KAMIRA AVENUE VILLAWOOD

RFI - URBAN DESIGN REPORT

JULY 2023

**KAMIRA AVENUE
VILLAWOOD STAGE 02**

SITE ANALYSIS

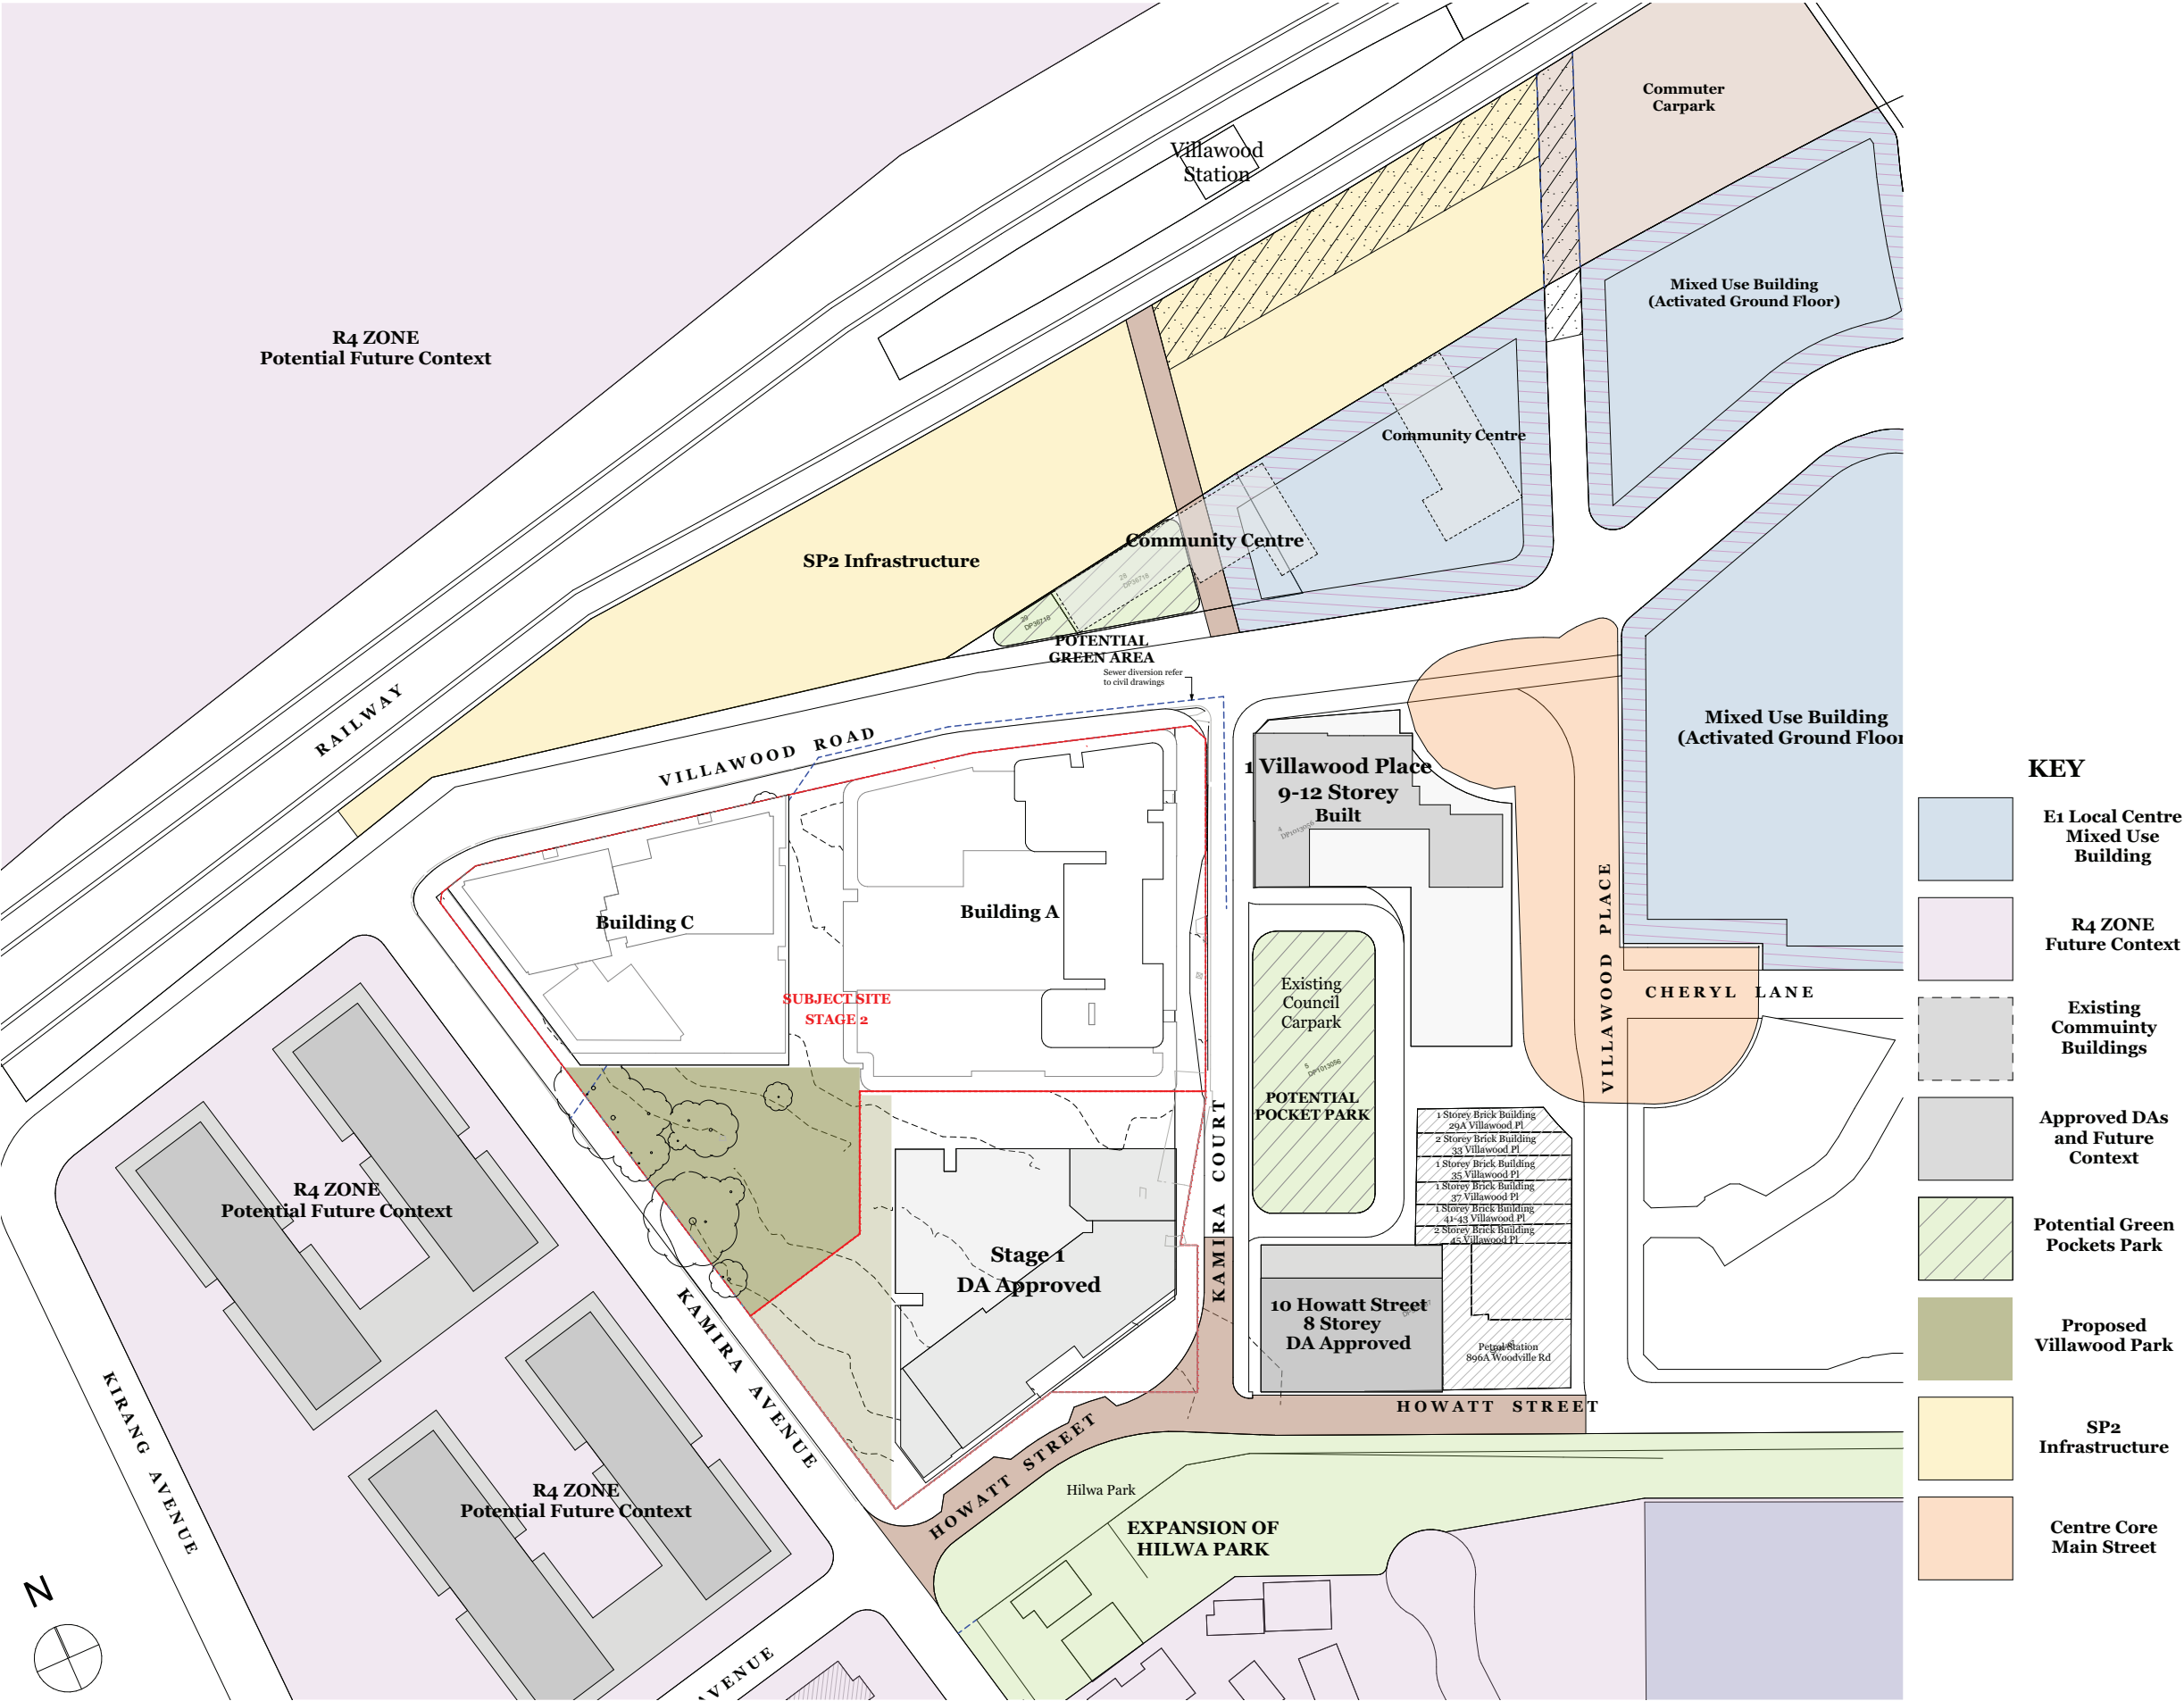
Accordingly, the 3D modelling shall be updated to include a schematic/concept-built form of the R4 residential precincts to the west and south. The current UDR presents these sites as single storey dwellings. It would also be beneficial to understand what is happening north of Villawood Road adjacent the rail line on the mixed-use site to better understand the character of Villawood Road and the gateway when arriving from the west and east.

The site analysis shall be updated to indicate the current Development Applications for adjacent buildings and the potential massing of the R4 sites to west and south.

The analysis plans shall include all public parks and street verges/public domain, major infrastructure such as substations etc in adjacent sites including Hilwa Park to provide a comprehensive analysis of the context of the town centre.

Site Analysis includes the contextual analysis of surrounding sites DAs approved adjacent to the site including 8 Howatt street and current built site 1 Villawood Place Future development to the south and west of site zoned as R4.

Site plan identifies key park expansions proposed within the DCP.

GROUND LEVEL AMENDMENTS

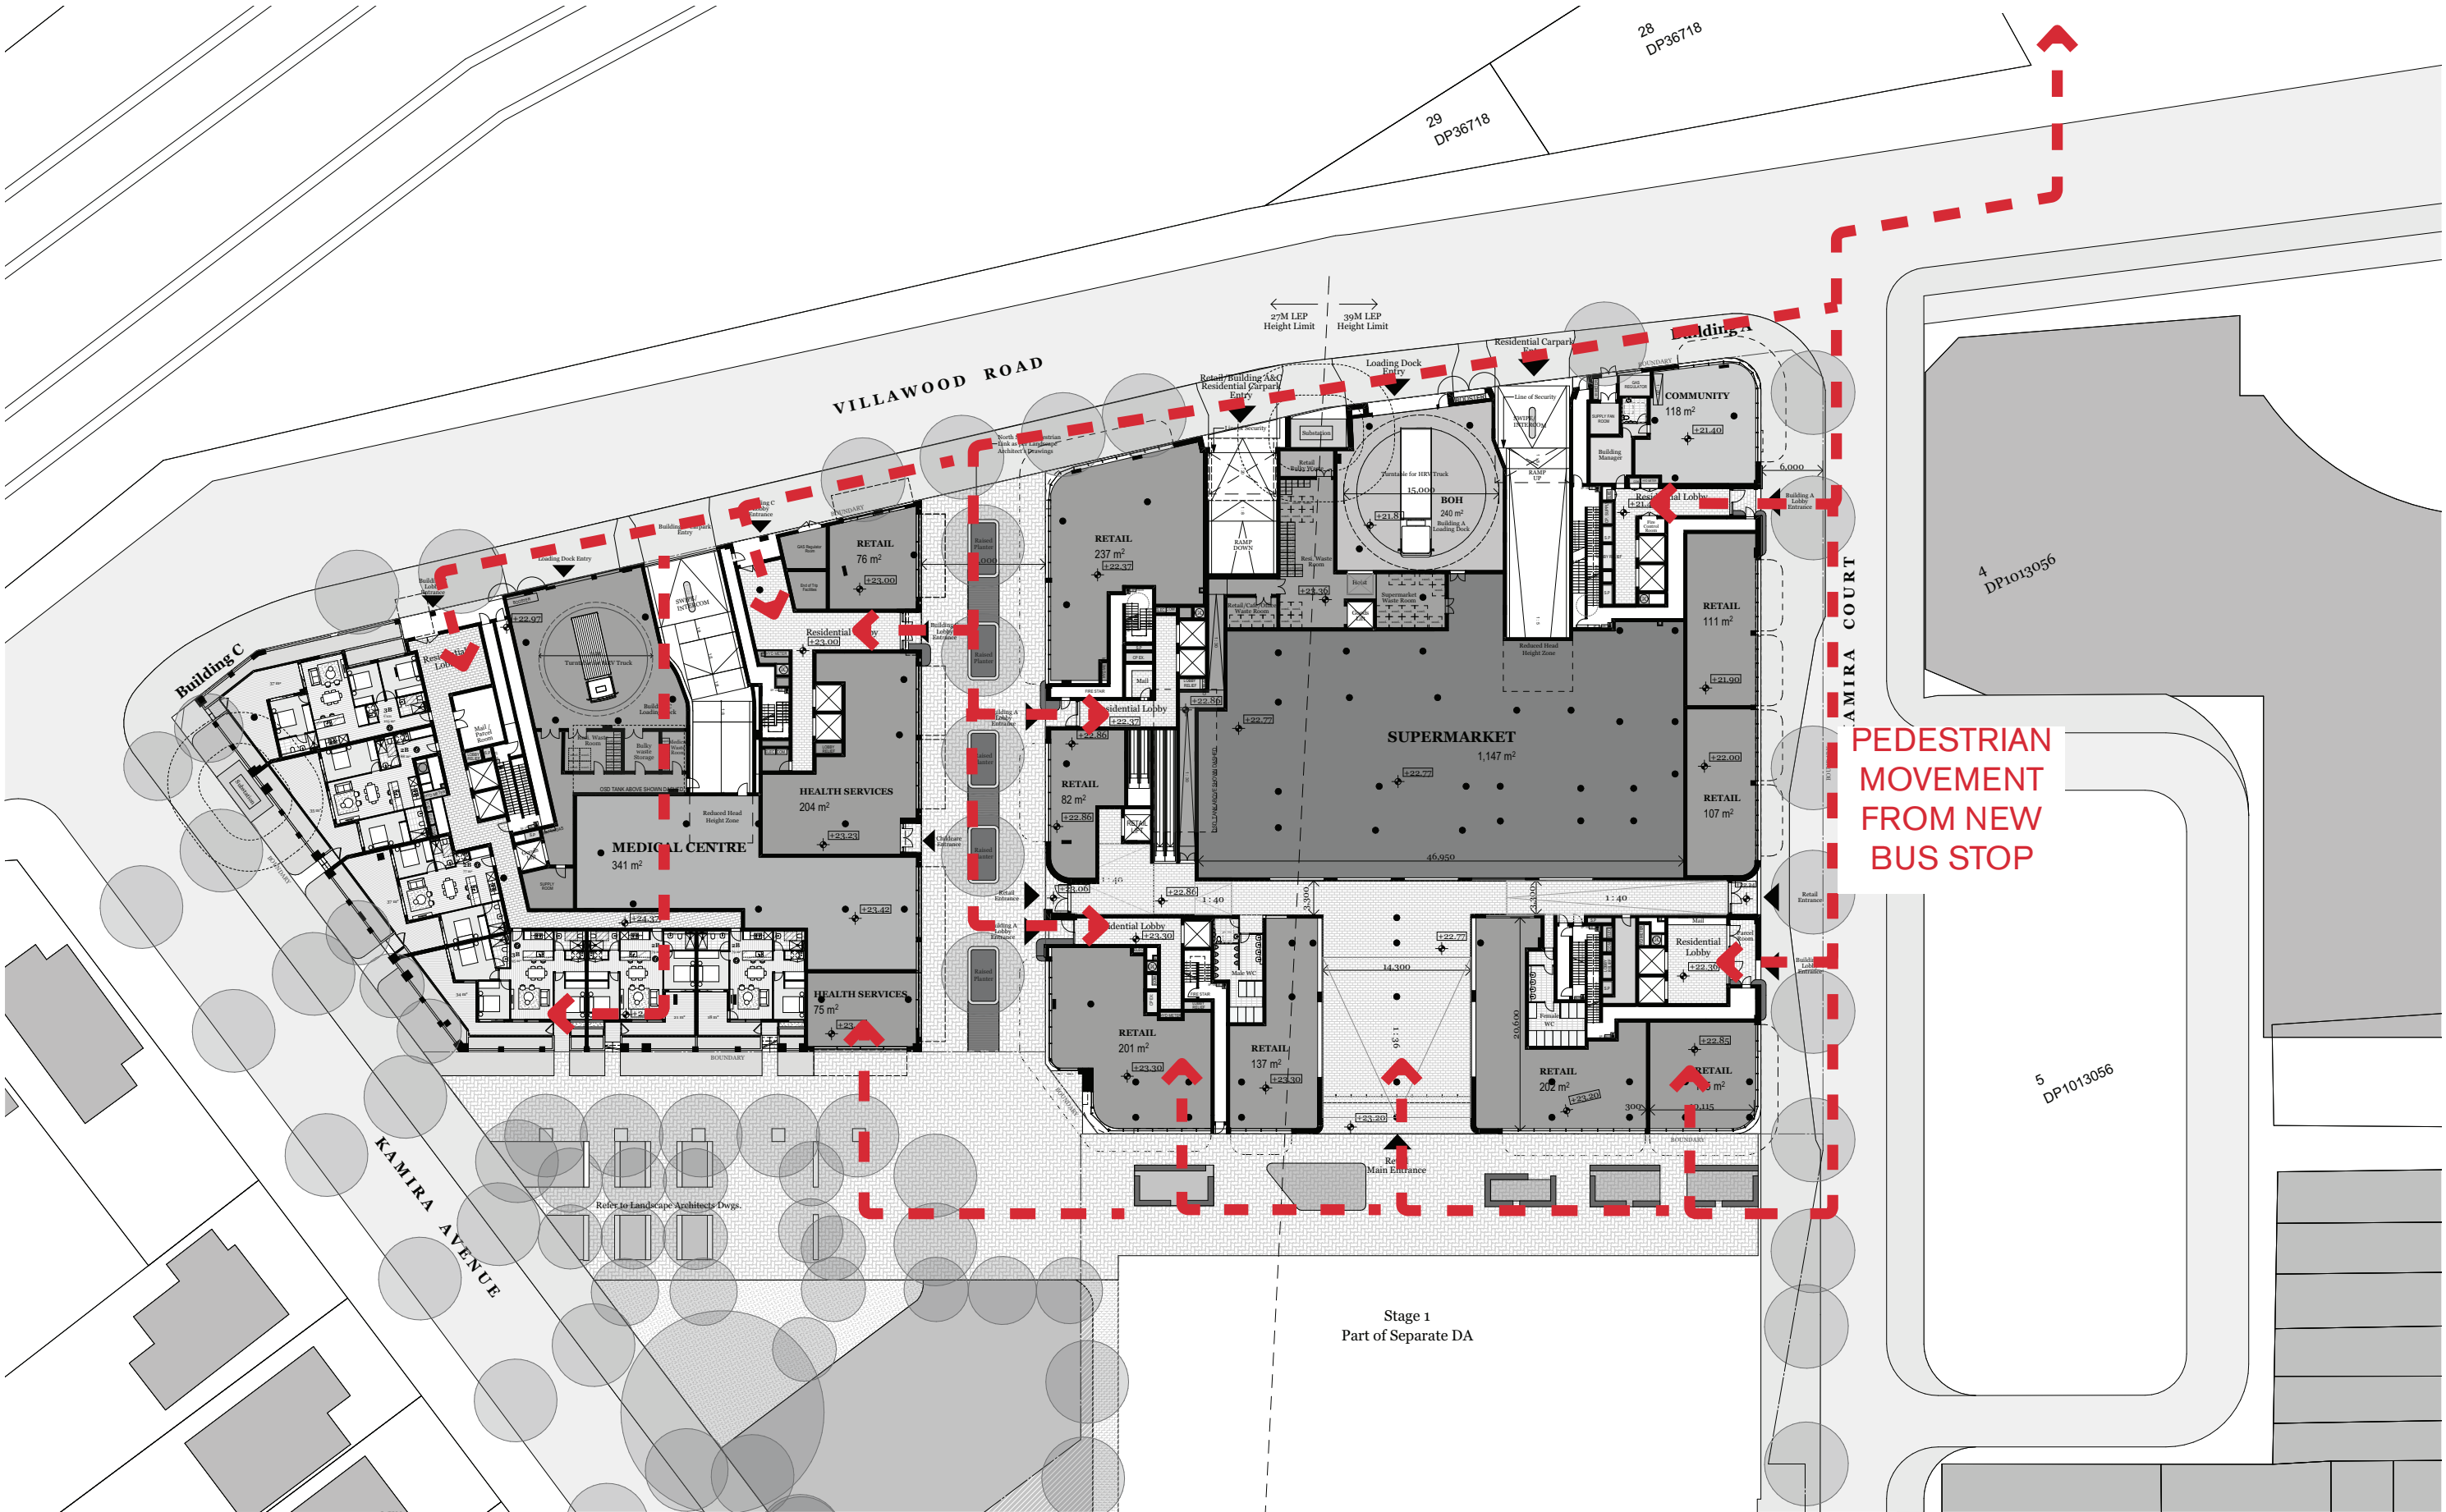
Clause 4.14 (Active Street Frontages) of the DCP requires active frontages and pedestrian links to be provided to encourage pedestrian activity to interact with the active shop fronts to create a positive, usable and attractive space.

The provision of the back of house areas, a substation and extensively screened facades along the childcare centre elevations on the ground floor results in loss of opportunity for street activation and connectivity to the proposed public park.

Accordingly, it is considered that this arrangement is not consistent with the objectives of the DCP. The applicant shall consider relocating the back of house areas into the basement and reconsider the location and design of the childcare centre in order to provide active uses on the ground level. Furthermore, the substation shall be provided within the building to reduce the visual impact of this structure.

New lobby entries have been introduced to Villawood road to provide a street address and reduce the back of house visual impacts. The removal of the child care centre provides improved activated edge to pedestrian link and Kamira Ave.

Further, a green buffer in street landscaping has been provided along the Villawood Road building frontage to mitigate the visual impact of the back of house as it presents to the street. See page 18 and also annexed landscape architect plans showing this detail.
